SUBMITTAL OF THE U.S. DEPARTMENT OF ENERGY, OFFICE OF RIVER PROTECTION (ORP) FINAL RESPONSES TO THE U.S. NUCLEAR REGULATORY COMMISSION REQUEST FOR ADDITIONAL INFORMATION (RAI) FOR SINGLE-SHELL TANK (SST) 241-C-106, RPP-RPT-26695

**RPP-RPT-26695, Rev. 0
NRC Staff Comments and DOE-ORP Responses Associated with DOE-ORP Documents
Establishing the Extent of Retrieval for Tank 241-C-106**

NRC Staff Comments and DOE-ORP Responses Associated with DOE-ORP Documents Establishing the Extent of Retrieval for Tank 241-C-106

SST Post-Retrieval Residual Contaminant Screening Process

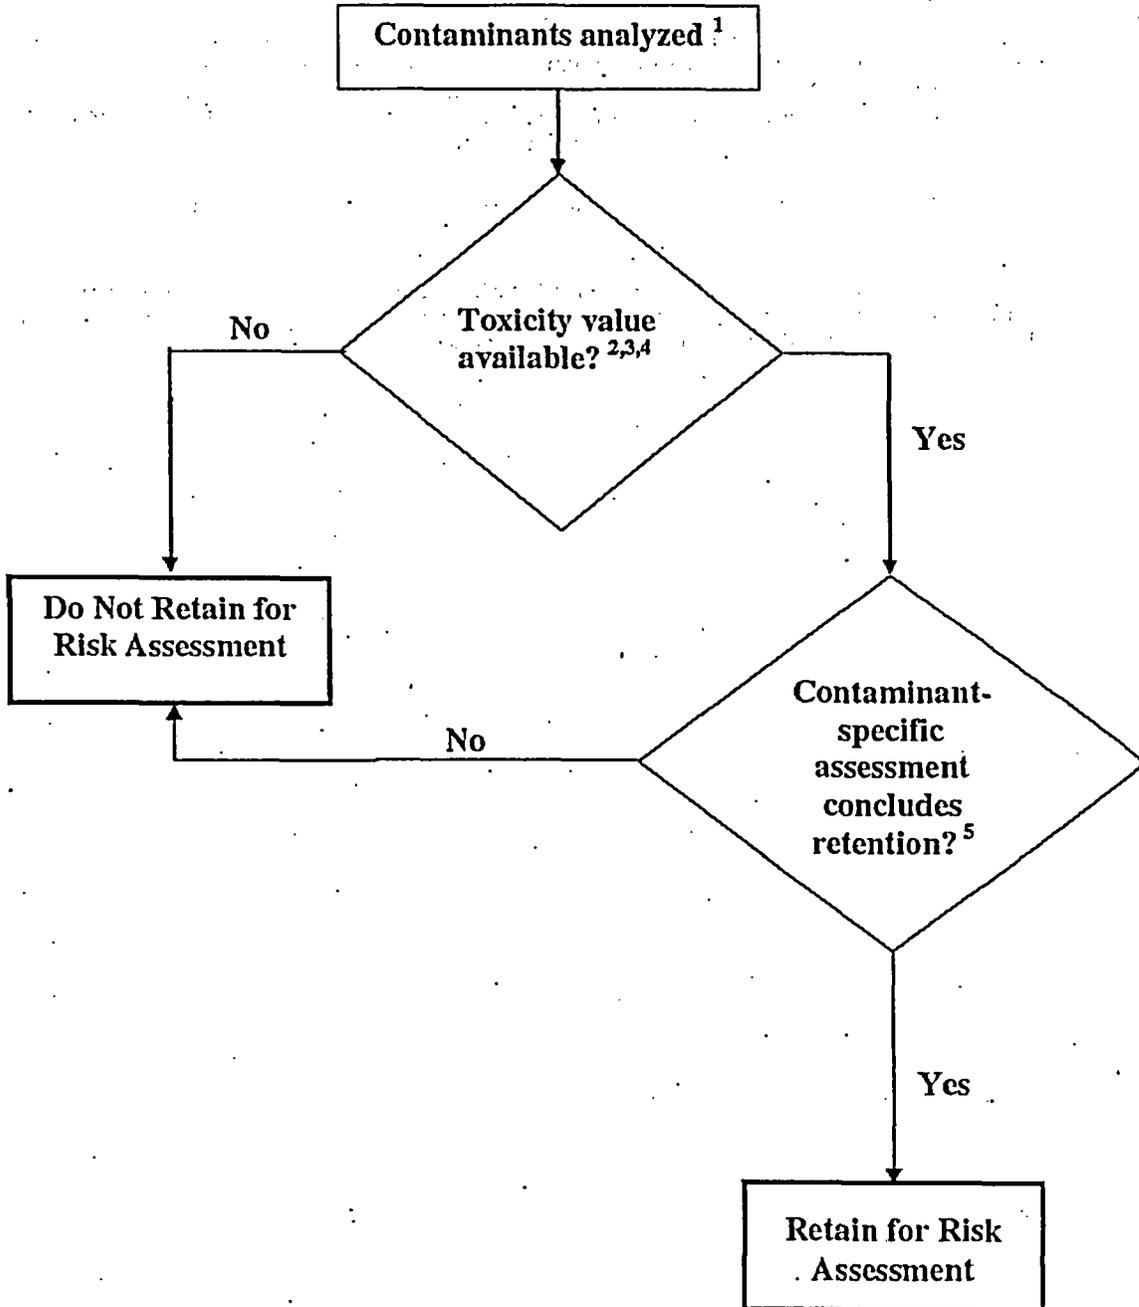
All contaminants that were detected by the laboratory in the post-retrieval sample were included in the risk assessment, provided that contaminant had either cancer slope factors or reference dose. The question became how to include those contaminants for which the laboratory analyzed in the post-retrieval sample, but fell below the laboratory's detection limits. Because it was an undetected constituent, half the detection limit was used to calculate an inventory left in the tank residue and an industrial ILCR and HI was calculated based on that inventory. However, it was pointed out during the review this dropped off I-129, a known COPC in tank waste.

The screening process is being modified per comments received by DOE from Ecology and the U.S. Nuclear Regulatory Commission (NRC). DOE has agreed to revise the screening process to include all detected and non-detected contaminants in the risk assessment unless there is a specific technical basis for excluding a non-detected contaminant from the analysis. For those limited non-detected contaminants, a basis of exclusion would be provided in the revised risk assessment. (See Attachment 1 for the revised screening process along with the attached Tables #1 and #2 that provide dose, risk, and hazard quotients for all analytes from the post-retrieval sample.)

In response to Ecology unless there are comments on the process used to screen contaminants for inclusion in the assessment of risk provided in RPP-20577 and summarized in RPP-20658, DOE has agreed to revise the screening process to include all detected and non-detected contaminants in the risk assessment unless there is a specific technical basis for excluding a non-detected contaminant from the analysis. For those limited non-detected contaminants, a basis of exclusion would be provided in the revised risk assessment. (See Attachment 2 for the revised screening process and notes.)
